APPROVED MINUTES

June 21, 2012 Standards Committee Meeting

1. CONCEPTUAL PROPOSAL
REVISION TO INDIANA DESIGN MANUAL

NOTES RELATED TO THE CHANGES TO THE AASHTO LRFD BRIDGE DESIGN SPECIFICATION 2012 6TH EDITION

Figure 409-2A

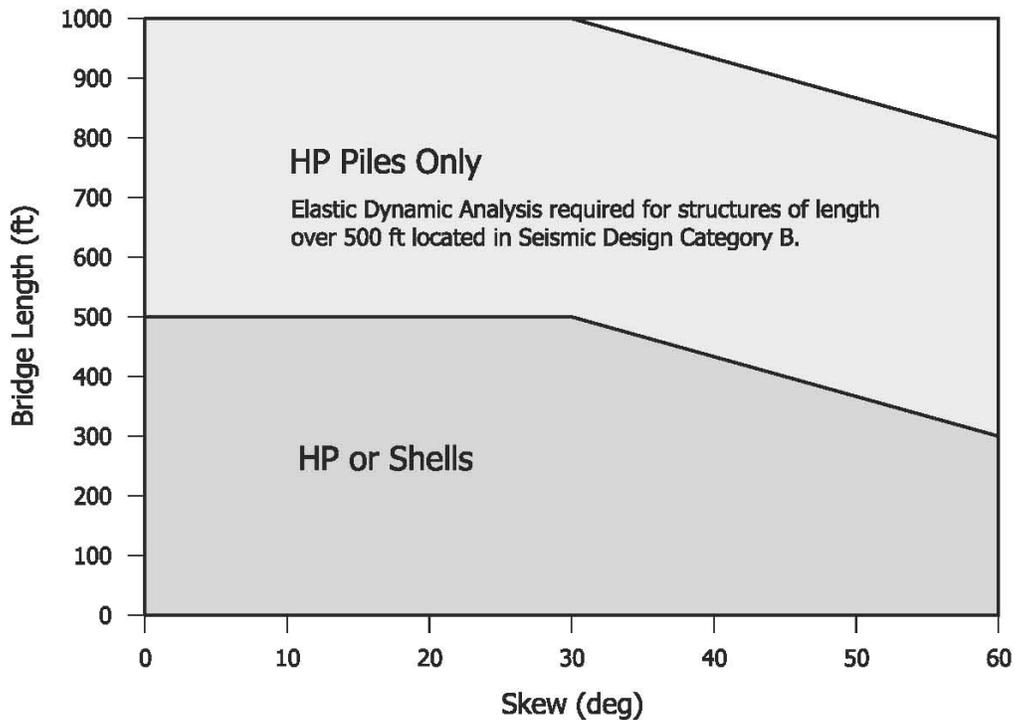
Integral end bents should be used for a new structure in accordance with the geometric limitations provided in Figure 409-2A. Minimum support-length requirements need not to be investigated for an integral-end-bent bridge. Integral structures 500 feet in length or less will not require seismic analysis. Integral structures larger than 500 feet in length and located in a seismic design category B will be analyzed using elastic dynamic analysis.

~~For an existing bridge without integral end bents, the design criteria shown in Figure 409-2A should be used in evaluating the conversion to an integral end bent structure. For additional information, see Chapter 412.~~

1. Integral abutments may be used in a curved-alignment or curved-girder structure with length of 500 feet or less, with a subtended angle in plan not greater than 30°.
2. Pile confinement spiral reinforcement required on all integral abutments.

Figure 409-2B

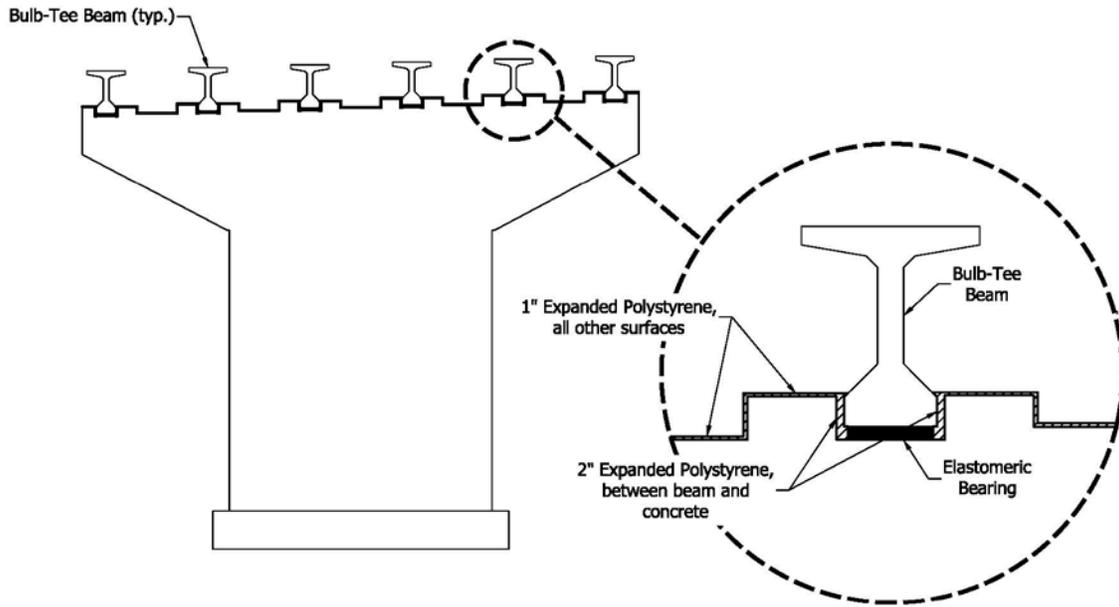
Figure 409-2A	Added new
Figure 409-2B	Added new
Figures 409-2C and -2D	Revised

7. Intermediate Pier Details for Integral Structures Located in Seismic Areas Greater Than SDC A. Intermediate piers should include concrete restrainers as shown in figure 409-XX

Figure 409-2E

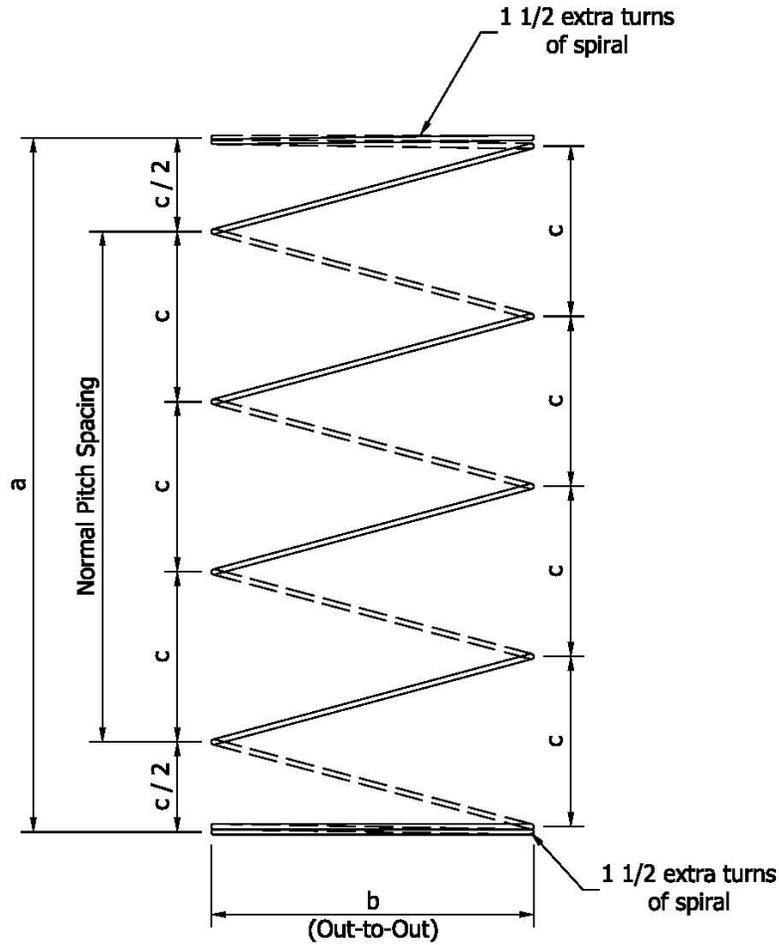
Figures 409-2E, -2F, and -2G	Added new
409-5.01	Reference to railroad track and crashwall has been deleted.
409-6.03(02)	Collision -static force revised from 400 kips to 600 kips.
409-6.03(03)	Reference to pier and location of the railroad track have been deleted.
409-7.03(03)	Rotation equations for the elastomeric bearing design have been deleted.
410-6.04(05)	Items 4 and 5 are revised. Figure relocated and reaction force for overturn was increased to two thirds from one-half.

TOOTH JOINT
 Figure 409-2F
 (Page 1 of 4)

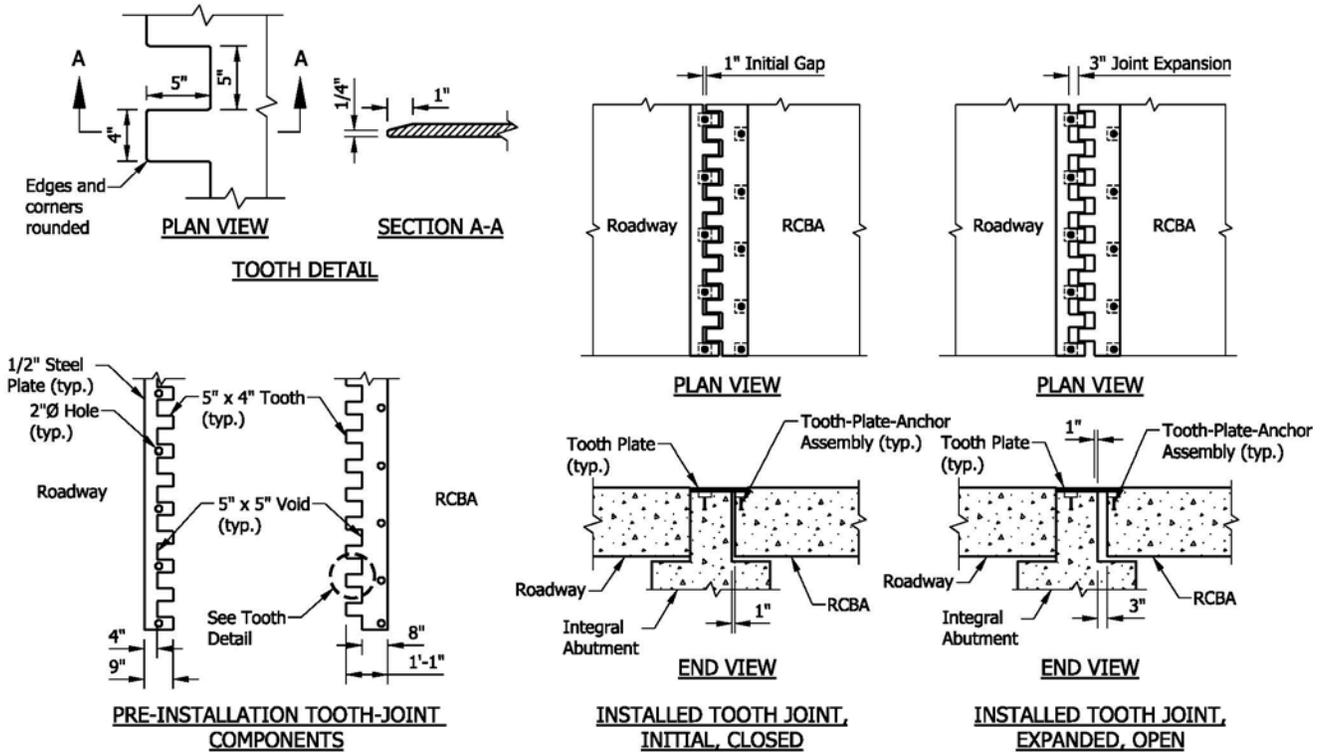
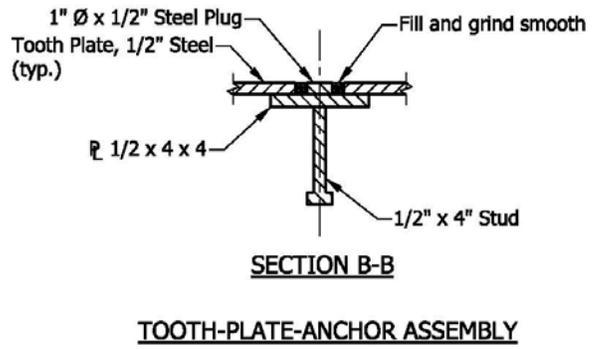
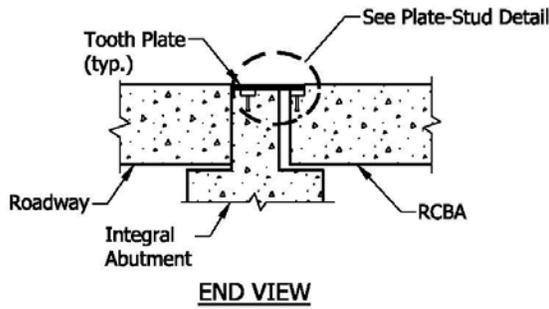
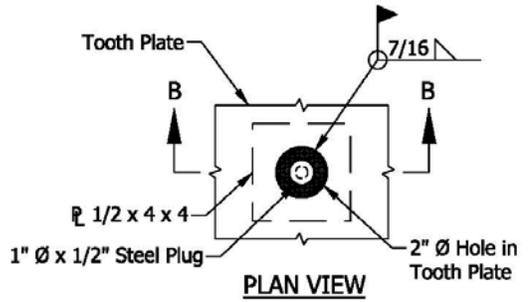
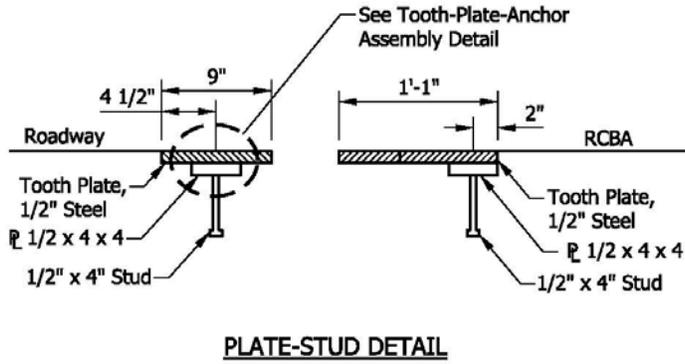
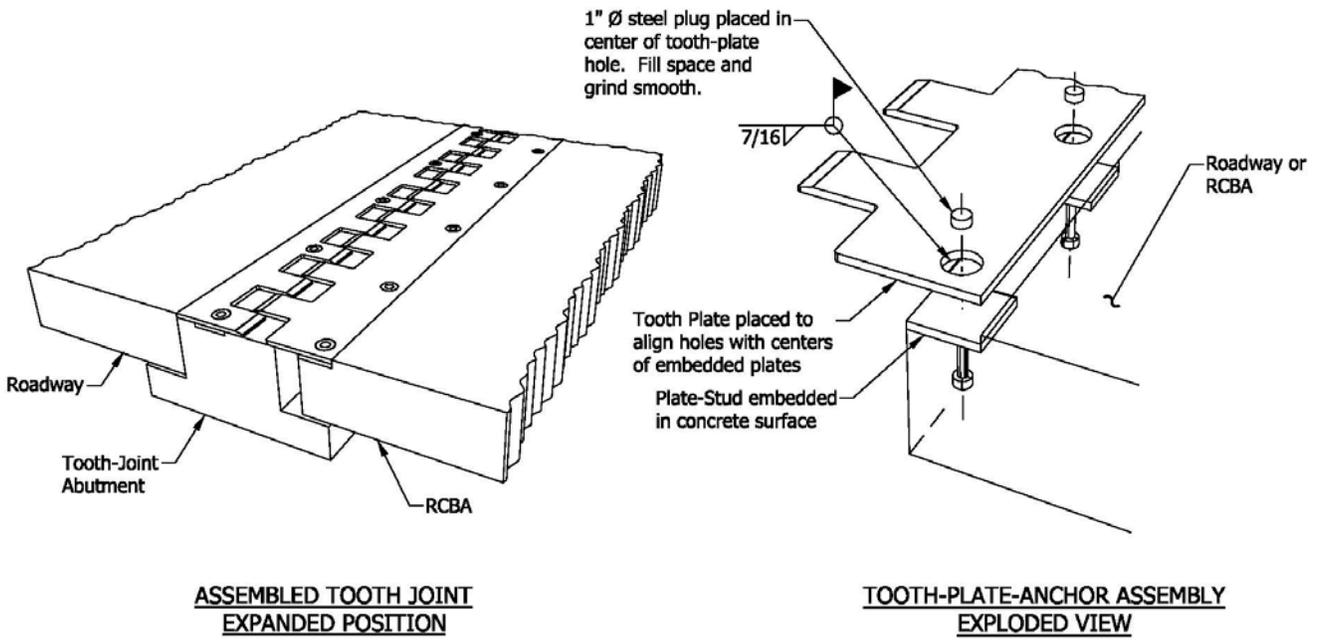
APPLICABLE DESIGN MANUAL SECTION: 409-2.04(02) item 3, and figure 409-2F

Mr. Pankow inquired as to whether there needs to be a standard drawing and become a part of the Design Manual. Mr. Uremovich mentioned that it can be detailed in the plans. Mr. Berebitsky concurred with Mr. Uremovich.
